# ADDENDUM 03

<b>TO</b>	All Plan Holders	<b>ISSUE DATE</b>	23 November 2022
		<b>PROJECT #</b>	17-006.12
<b>REGARDING</b>	<b>Reroof &amp; Mechanical, Exterior Painting, Window Replacement at Mission Hill Middle School</b>	<b>NARRATIVE PAGES</b>	1
		<b>SPECIFICATION PAGES</b>	0
<b>DISTRICT</b>	Santa Cruz City Schools District	<b>DRAWING SHEETS</b>	3
		<b>TOTAL PAGES</b>	4

1-1/2"=1'-0" 1

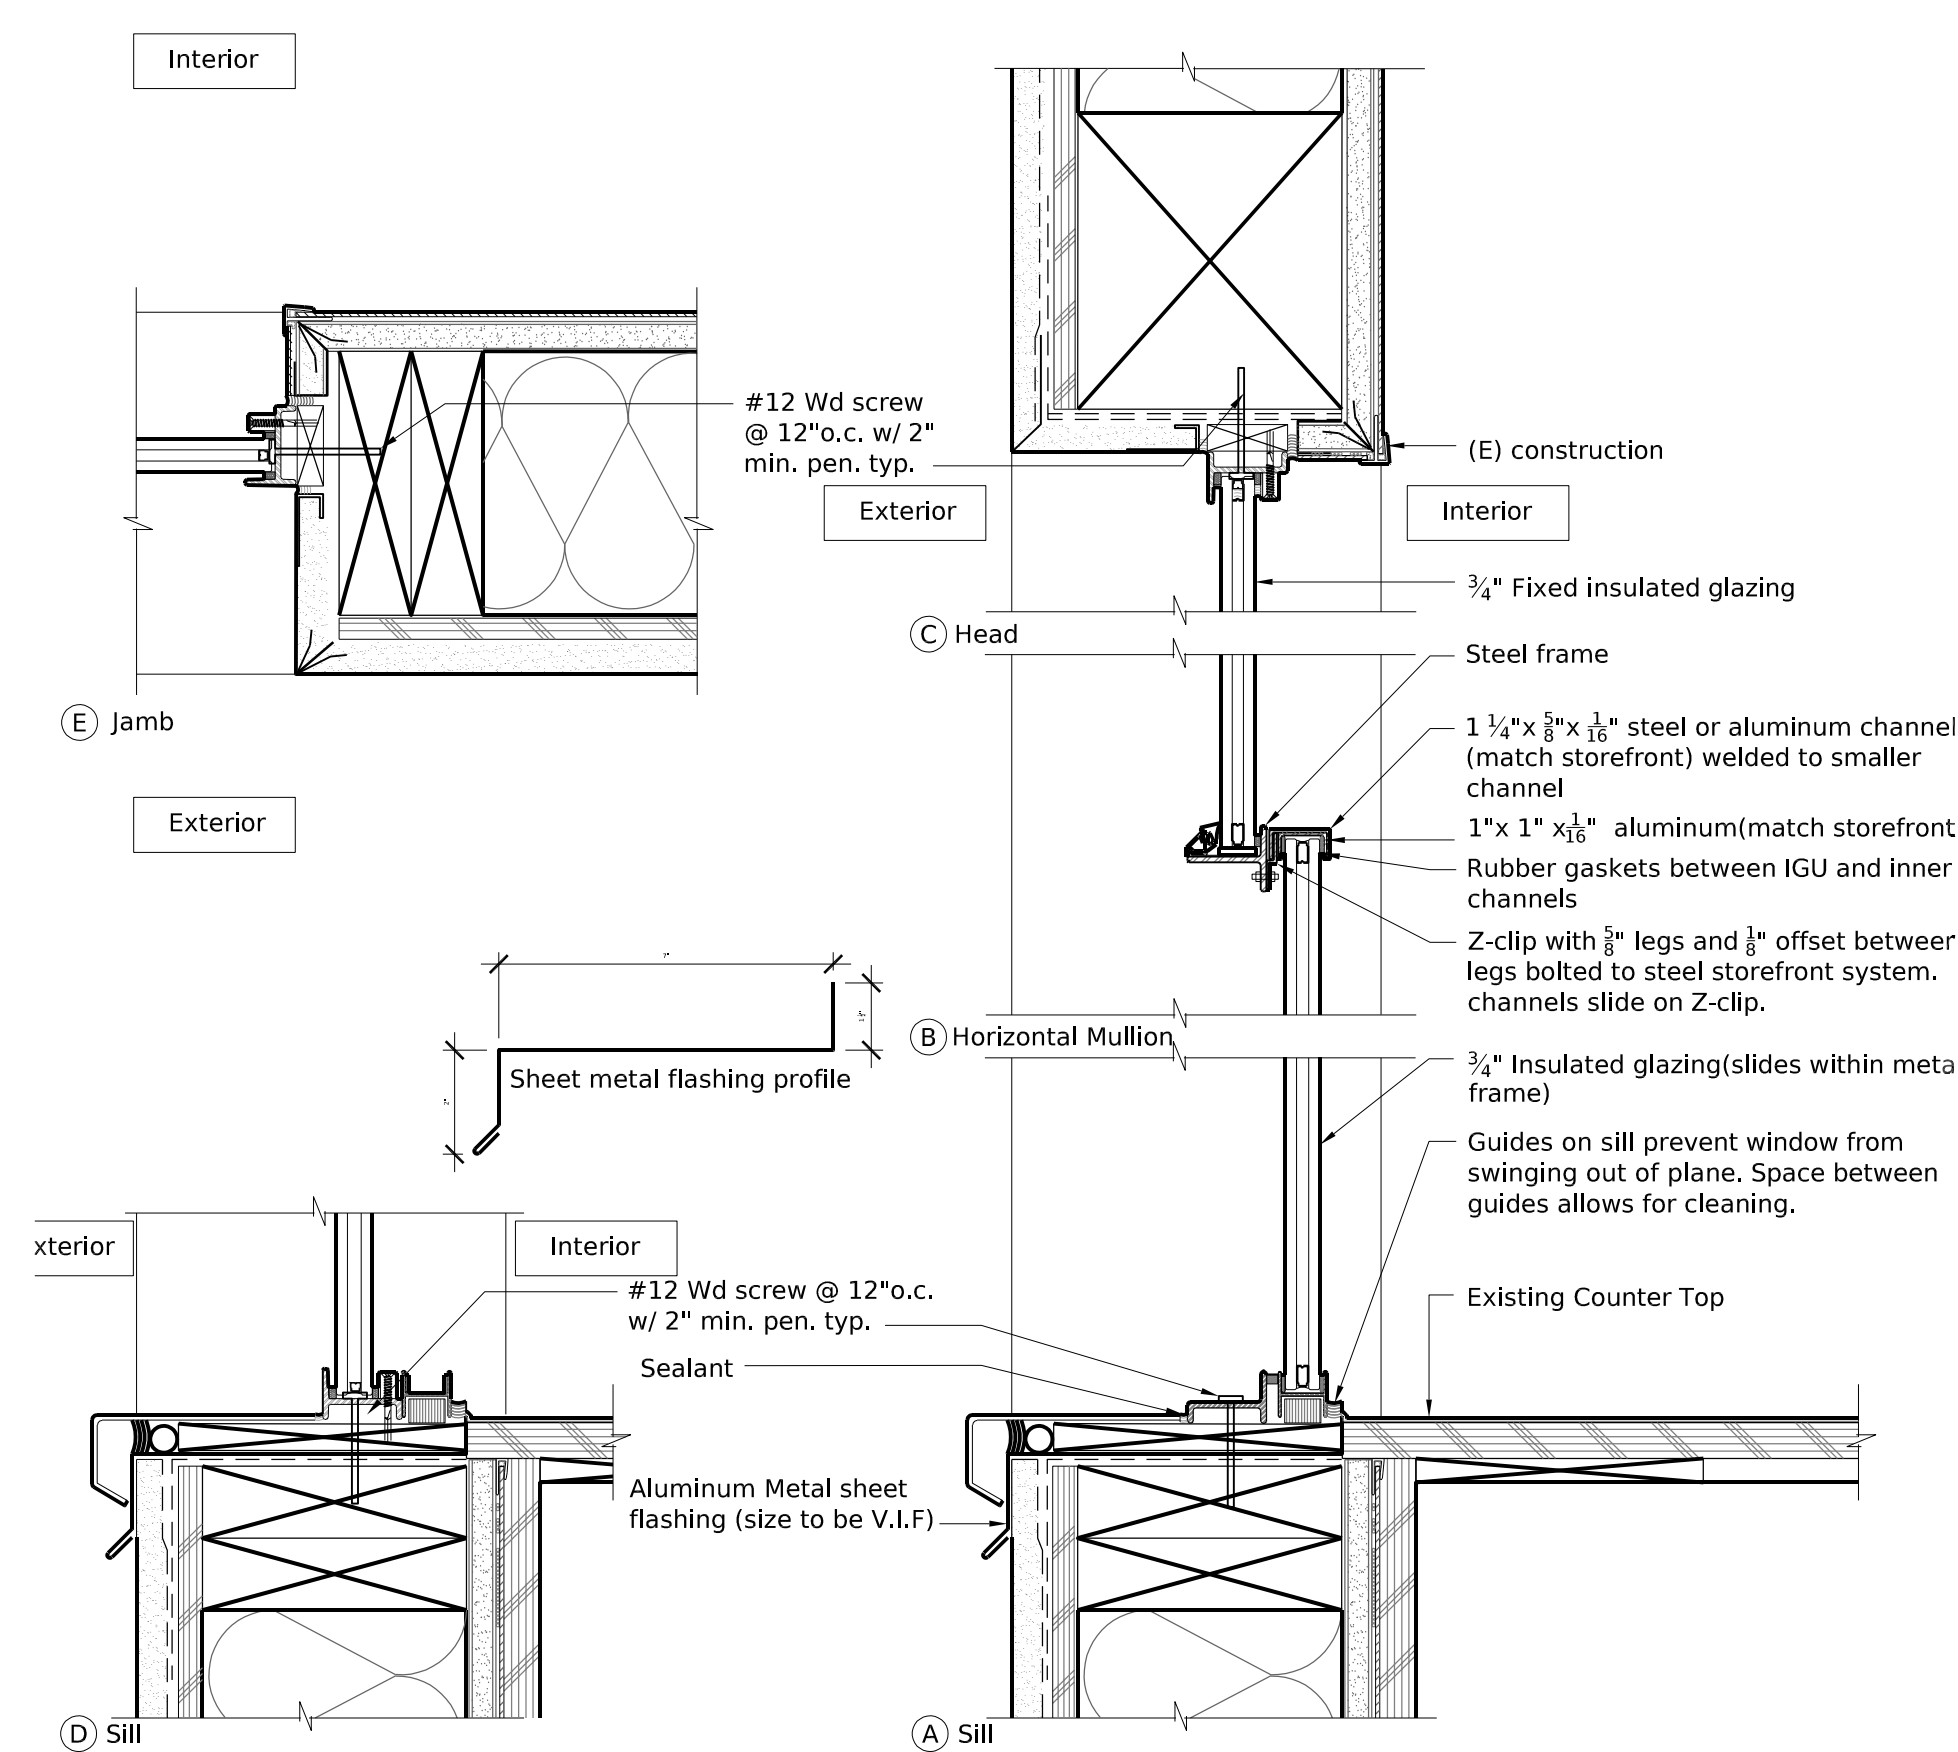
- Interior Trim at windows** • Clarification: Sheet A7.0 is hereby re-issued in its entirety as AD3-W1
- Provide panning over existing sills/jams/heads. Place over existing interior trims
- AD3-W1** • Base bid shall Include allowance **\$10,000** for wood trim necessary at special locations.
- Any new trims shall match existing dimension and profile
